## PACIFIC ROCK QUARRY EXPANSION PROJECT

# **FINAL ENVIRONMENTAL IMPACT REPORT**

*STATE CLEARINGHOUSE NO. 2017081052*

### **VOLUME I – MAIN DOCUMENT**

**Figure 1:** Mountain Lion GPS Data Points of lions P-1 through P-22 from 2002 through 2013 (NPS 2015).

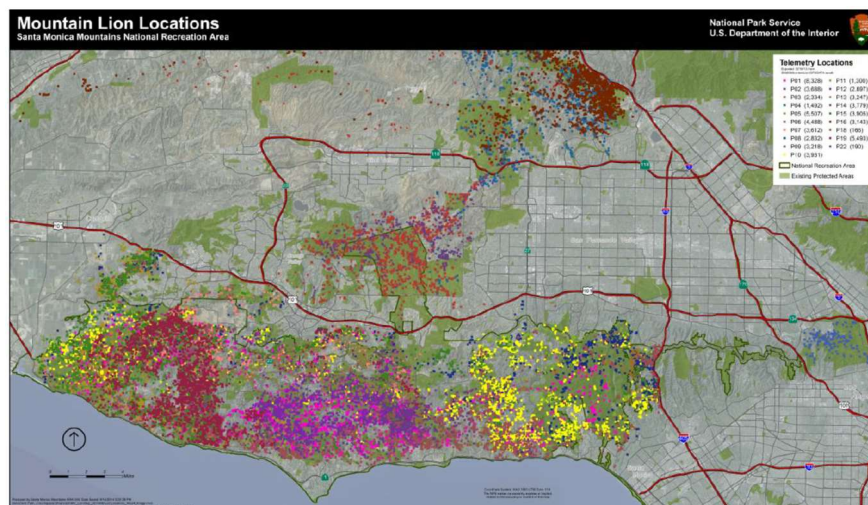
The DEIR falsely and inappropriately concludes that mountain lions (*Puma concolor*), a candidate species under the California Endangered Species Act, have a “moderate” potential to occur within or adjacent to the Project site (DEIR at 3.5-18), when in fact they should be categorized as “Present.” The Project site is located in high quality mountain lion habitat within one of the last remaining corridors between the Santa Monica Mountains and the Sierra Madre (Penrod et al. 2006) and there is a wealth of data from the National Park Service (NPS) that demonstrates their presence in and adjacent to the Project area. Maps of the NPS data are publicly available at [www.flickr.com](http://www.flickr.com), and they clearly show that the area is used by mountain lions. Figure 1 shows NPS telemetry locations for lions P-1 through P-22 from 2002 to 2013 (from GPS collars on individuals), and numerous individuals were documented in and adjacent to the Project site. Similarly, Figure 2 shows the home ranges of several mountain lions encompassing the Project area. Figure 3 shows predation sites where collared mountain lions fed on mule deer, some of which are located in and adjacent to the Project area (Benson et al. 2016b). This clearly shows that the DEIR fails to adequately assess the Project’s impacts to mountain lions, as they provide a false representation of the likelihood of mountain lions being present, using, and moving through habitat in and near the Project area. Mountain lions should be considered “Present” in and adjacent to the Project site.

In failing to adequately determine the presence of mountain lions in and near the Project site, the DEIR fails to adequately assess impacts to mountain lions. The Project would have insurmountable impacts on struggling local mountain lions. Local mountain lions are at risk of extinction as their genetic health deteriorates due to inbreeding caused by roads and development slicing through their habitat and isolating populations (Ernest et al. 2014; Riley et al. 2014; Vickers et al. 2015; Gustafson et al. 2018; Benson et al. 2019). Low genetic diversity combined with high human-caused mortalities (e.g., from car strikes, depredation kills, rodenticide poisoning, and poaching) threaten the long-term survival of several populations. Mountain lions in the Santa Monica Mountains are especially imperiled, as abnormalities linked with inbreeding depression was recently observed. [Footnote: News Release: NPS Biologists Report First Abnormalities Linked to Inbreeding Depression in Mountain Lions P-81, a Subadult Male, Has Reproductive and Tail Defects. Available at: <https://www.nps.gov/samo/learn/news/first-abnormalities-linked-to-inbreeding-depression.htm>] Should inbreeding depression occur, scientists predict there is a >99% chance of extinction, which could occur within as little as 15 years (Benson et al. 2019). Therefore, high quality habitat that is being used by mountain lions within one of the last remaining natural corridors between the Santa Monica Mountains and the Sierra Madre is critical for the population’s long-term survival. The DEIR fails to adequately assess the severely low genetic diversity of the Santa Monica Mountains puma population that is driven by isolation and the significant impacts the Project will have on this population by eliminating portions of the corridor and degrading connectivity in the area.

Figure 4: Wildfire Ignition Points in the Santa Monica Mountains and Vicinity (NPS 2018).

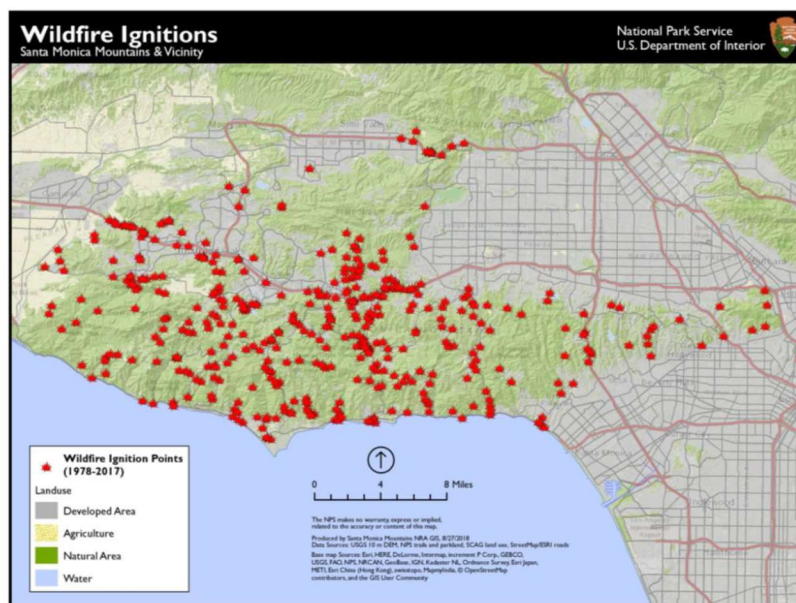
The DEIR fails to adequately assess the impacts of increased wildfire ignitions due to the Project on mountain lions. Most wildfires in California are caused by human ignitions, like power lines, arson, improperly disposed cigarette butts, debris burning, fireworks, campfires, or sparks from cars or equipment (Keeley and Syphard 2018). In fact, almost all (95–97%) contemporary wildfires in California are caused by humans and human infrastructure (Syphard et al. 2007; Balch et al. 2017; Keeley and Syphard 2018; Radeloff et al. 2018; Syphard and Keeley 2019; Keeley and Syphard 2020; Syphard and Keeley 2020). In the Santa Monica Mountains, fires from 1978–2017 were often ignited near roads and other human infrastructure (Figure 4).

<b>Chapter 3</b>		
Figure ES-2	Site Location .....	3-9
Figure 2-2	Site Location .....	3-11

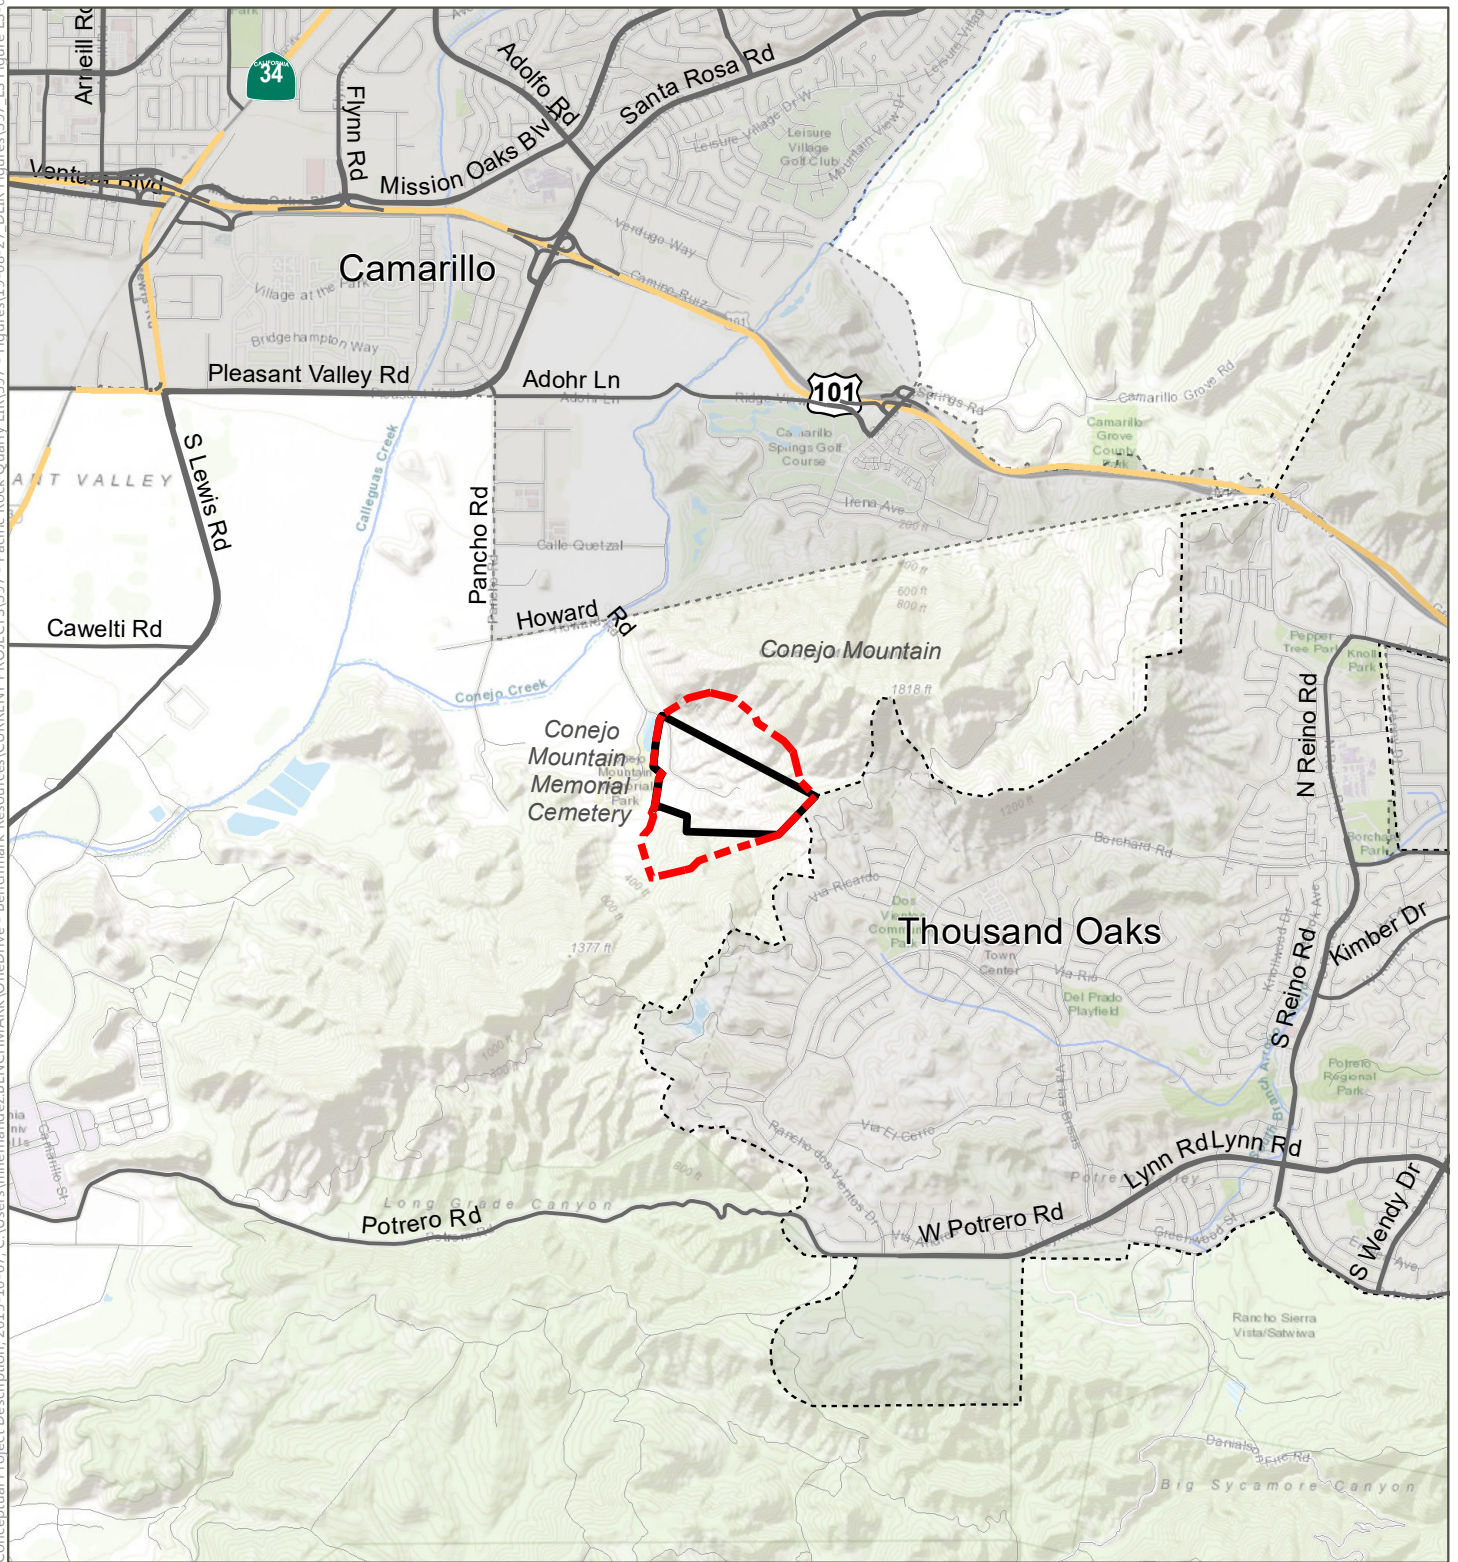
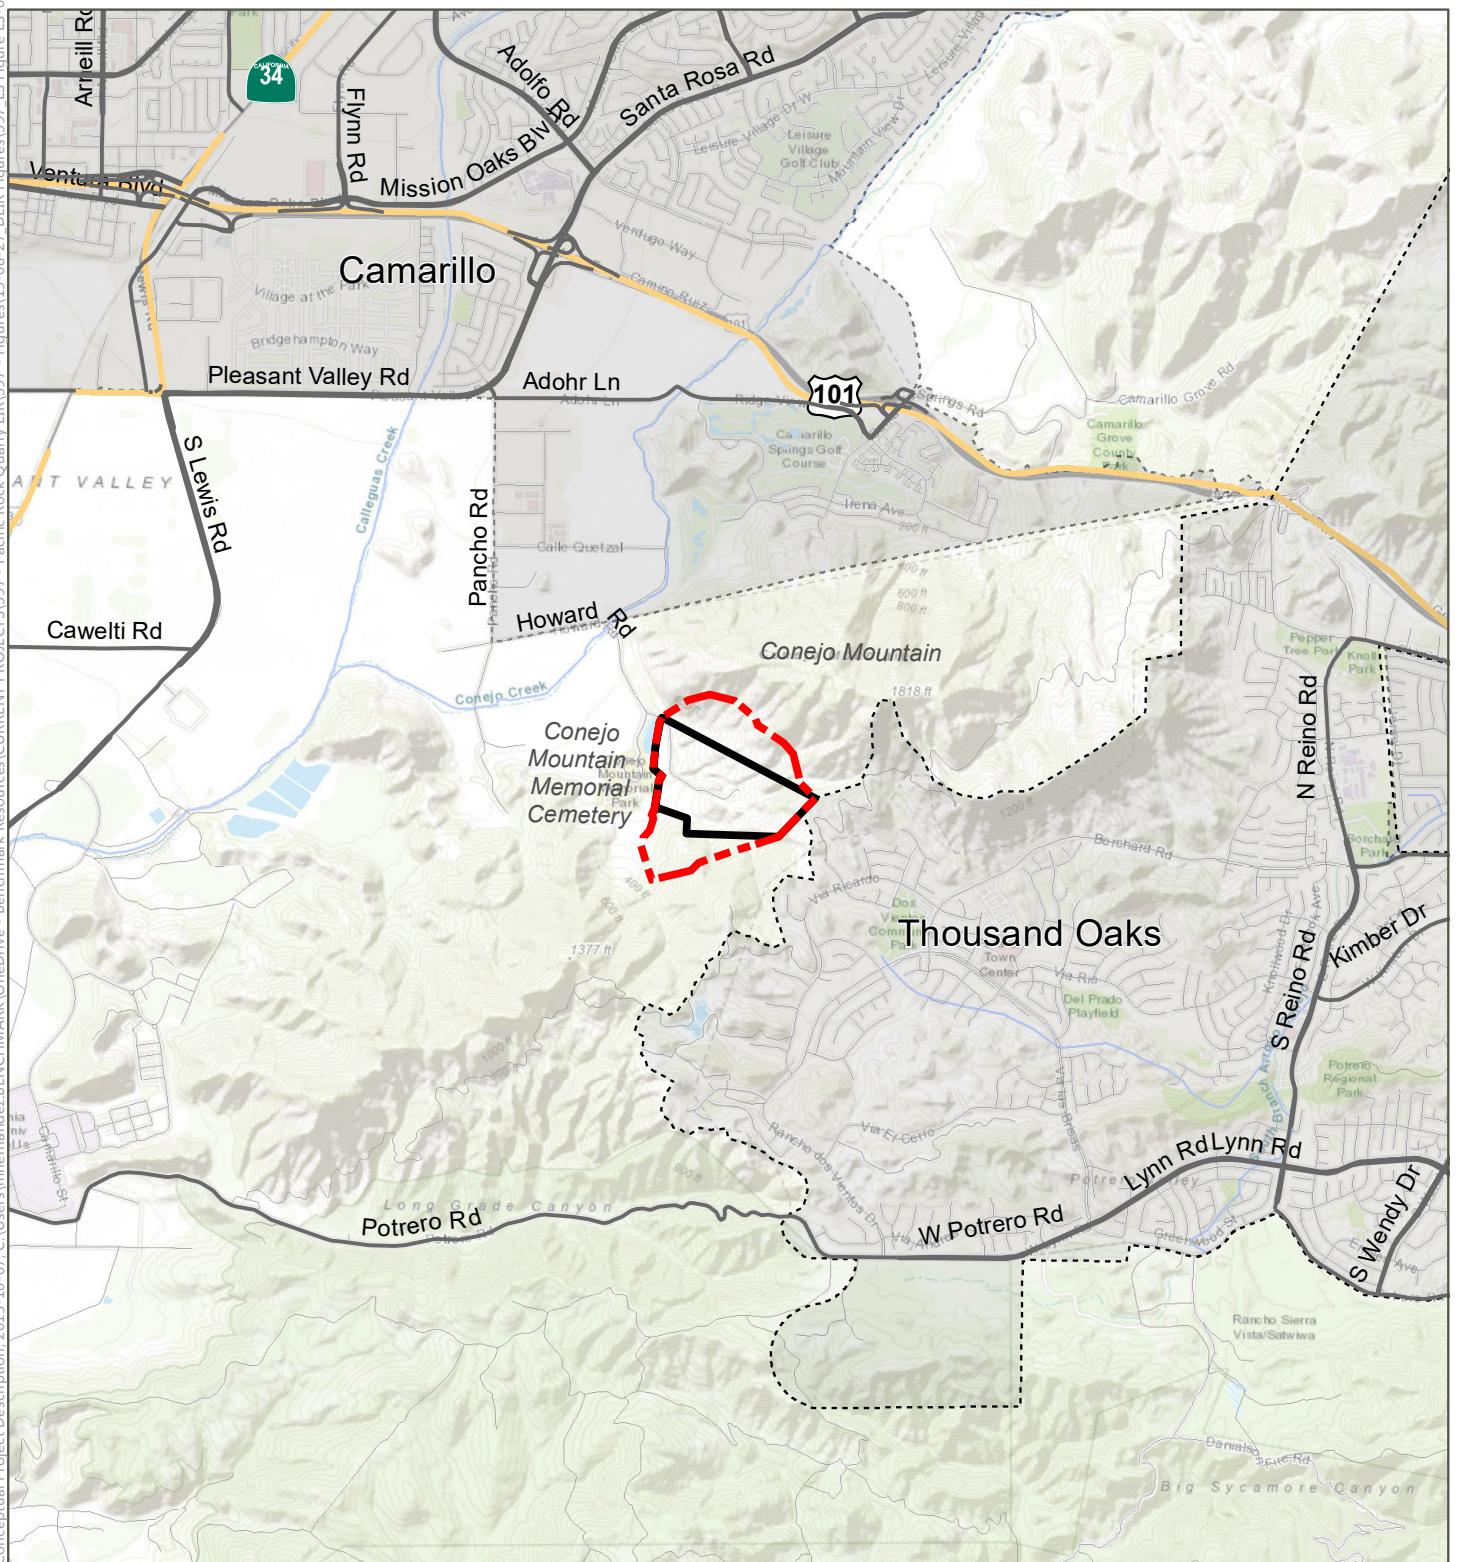
The commenter notes an illustrative error on Figure ES-2, and the Project boundary does not encroach into the City of Thousand Oaks. Figures ES-2, 2-2, 3.2-1, and 3.5-3 have been revised in the FEIR (see FEIR Chapter 3) to correct the City of Thousand Oaks boundary which was inadvertently shown as overlapping with a portion of the Project CUP boundary/property. This change in the boundary linework on the referenced figures does not affect the analysis or conclusions of the DEIR.

DEIR Figures ES-2, 2-2, 3.2-1, and 3.5-3 inadvertently showed a boundary for the City of Thousand Oaks as overlying a portion of the Project site. The City of Thousand Oaks boundary is adjacent to a portion of the eastern boundary of the Project site, but the Project properties are not within the City of Thousand Oaks. Figures ES-2, 2-2, 3.2-1, and 3.5-3 have been revised for this FEIR to correctly show the City of Thousand Oaks boundary as adjacent to the Project site. The revised figures are included at the end of this chapter. The analysis and conclusions of the DEIR and PRDEIR properly considered the Project as located entirely within unincorporated Ventura County and adjacent to, but not within, the City of Thousand Oaks. The figure revisions do not affect the analysis or conclusions of the DEIR or PRDEIR. Additionally, Figure 3.5-3 has been modified to identify a wildlife corridor preservation area as part of the Biological Resources Errata, as discussed further in Section 3.3, Errata 18, below.

#### **Errata 6. Location of Portable Recycle Plant on DEIR Figure 2-5**

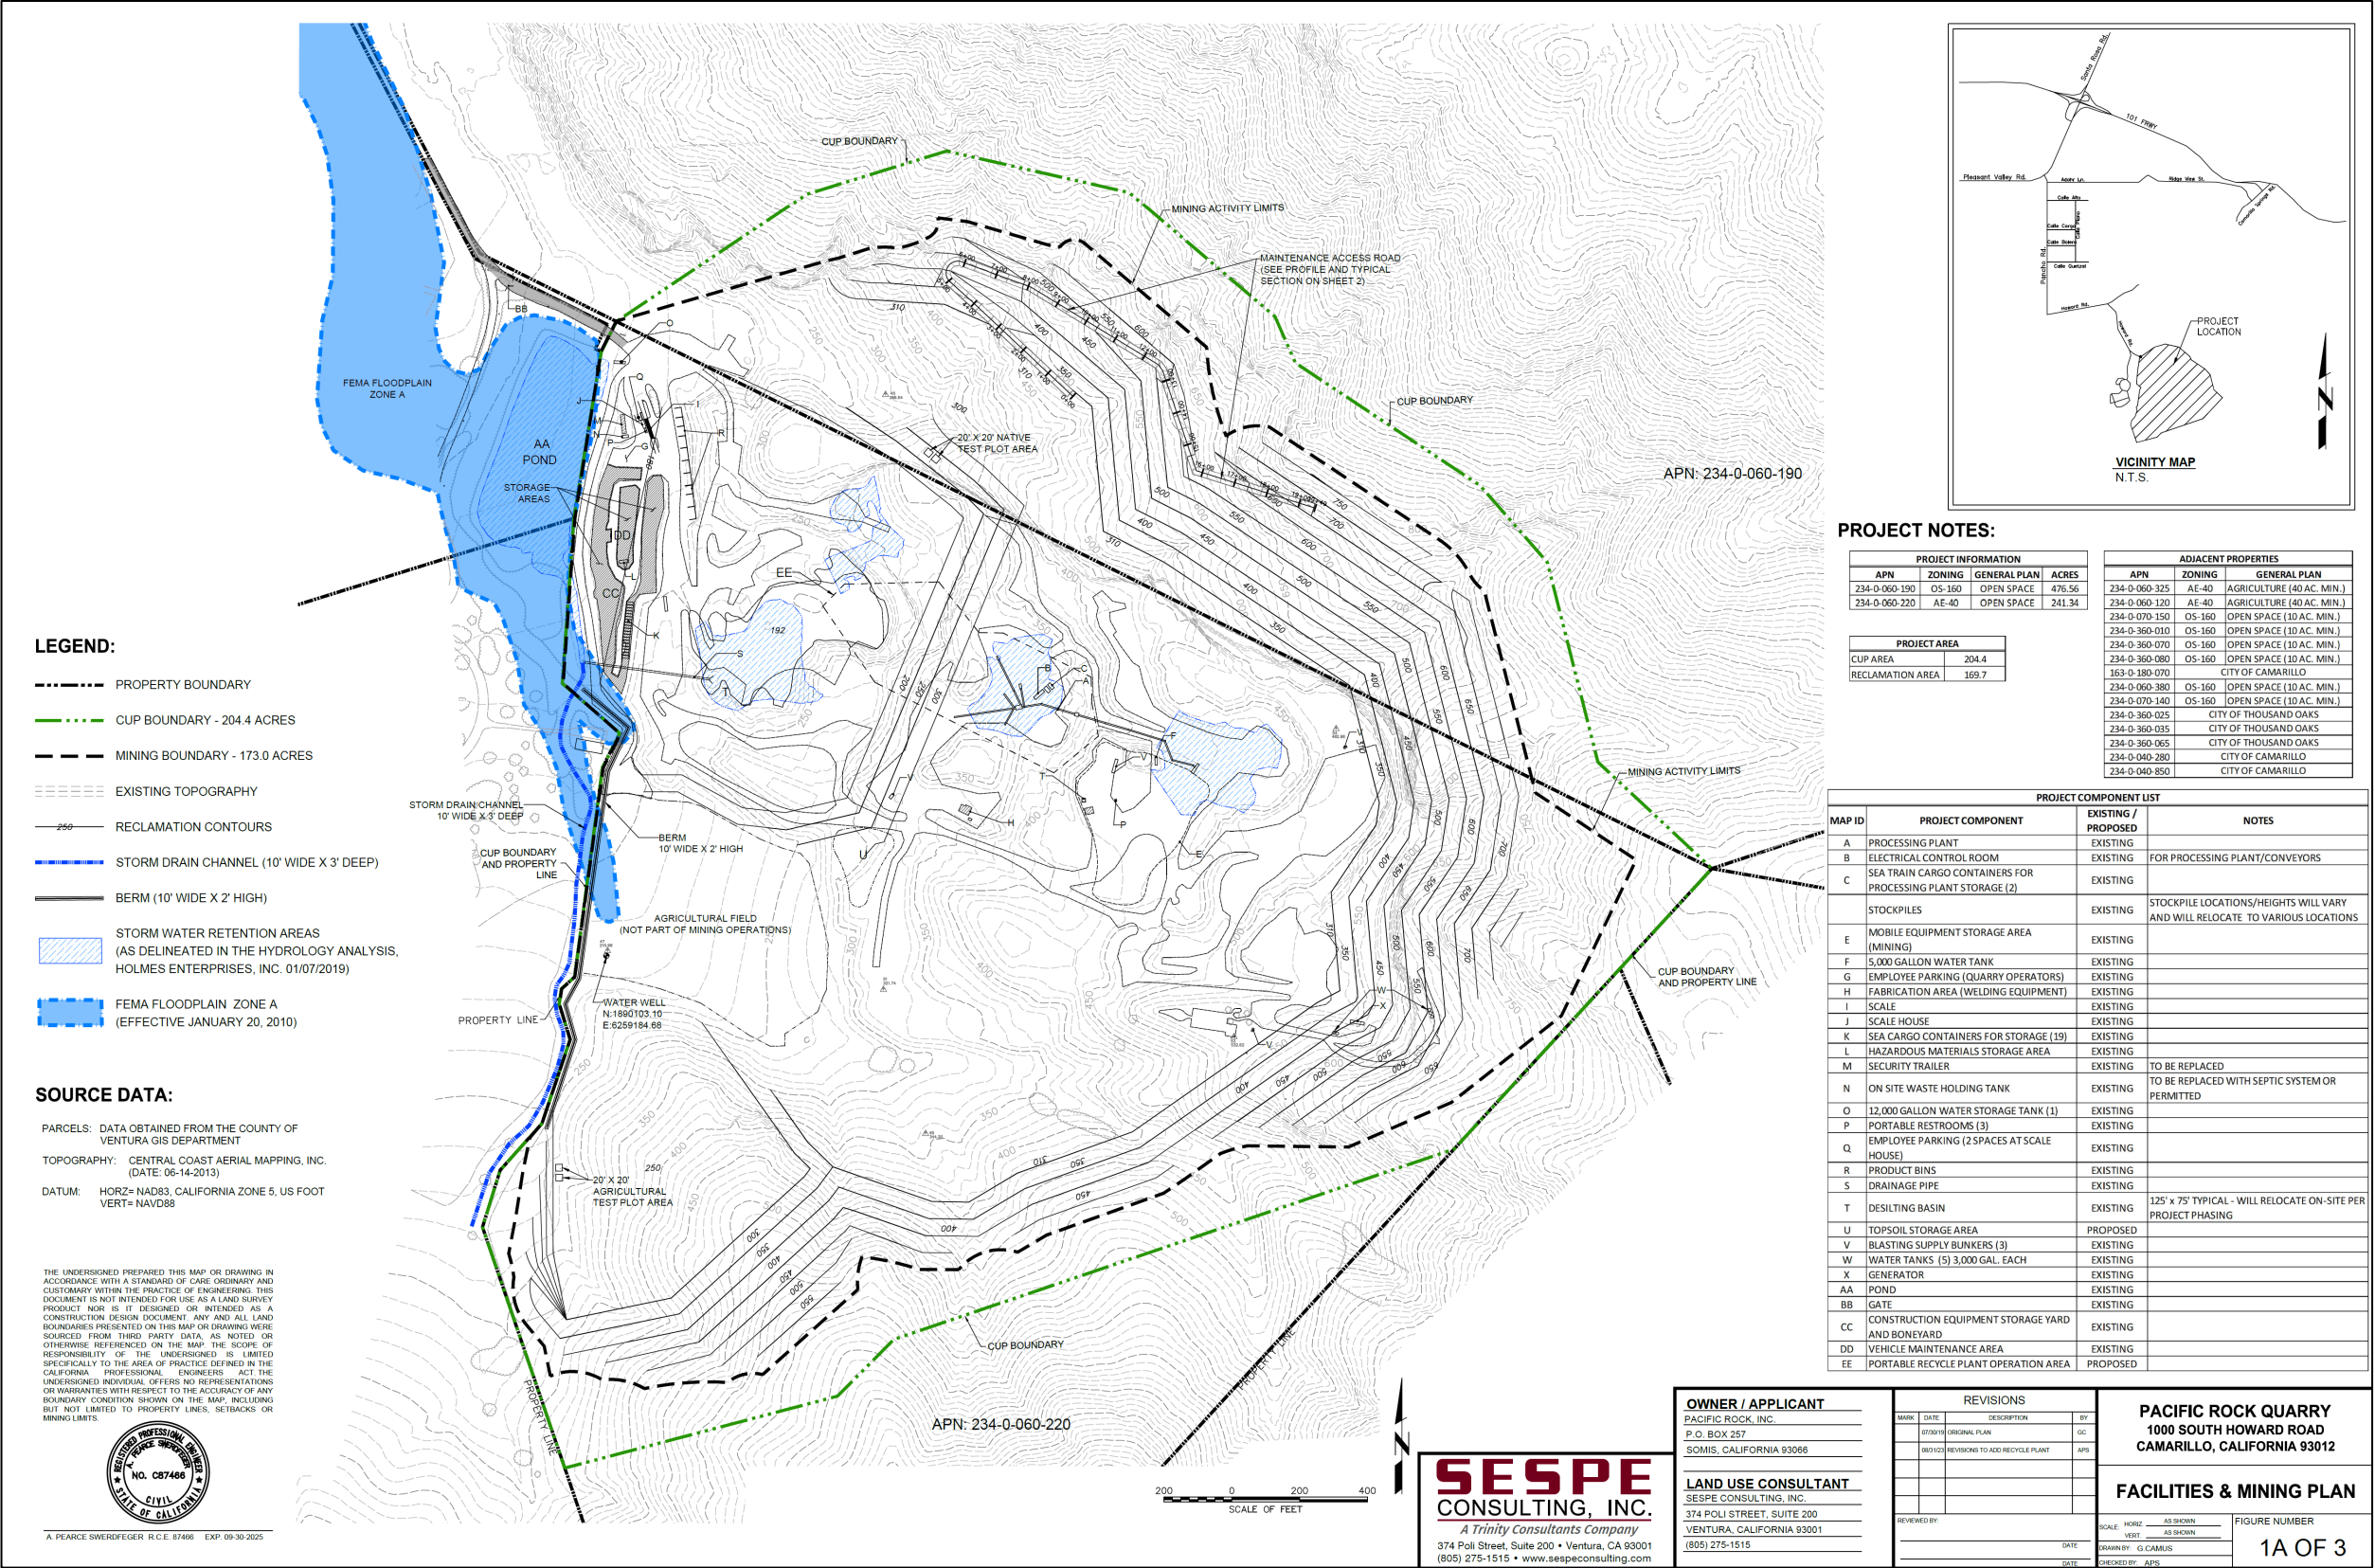
We cannot see the location of the recycling plant on Fig 2.5, as suggested. That should be corrected in the final EIR. The location is shown on Figure 3.8.1 but not in a precise manner.

The commenter is correct that DEIR Figure 2-5 does not illustrate the area within which the portable recycling plant is proposed to be located. As noted in the comment, Figure 3.8.1 of the DEIR identifies the area within which the recycling plant would be located, thus, this information was presented in the DEIR. Chapter 3 of this FEIR provides an errata updating Figure 2-5 to include the portable recycling plant operational area.

As discussed on page 2-12 of the DEIR, the Project includes the operation of a portable recycling plant. The proposed area within which the portable plant would operate was illustrated on DEIR Figure 3.8-1, but was not illustrated on DEIR Figure 2-5 in DEIR Chapter 2, “Project Description.” To clarify the proposed operational area of the recycle plant, Figure 2-5 has been revised for this FEIR to label and delineate the recycle plant operational area. The revised Figure 2-5 is included at the end of this chapter.

- Figure not to scale.
- Revised for Final EIR to include proposed portable recycle plant operation area (EE).
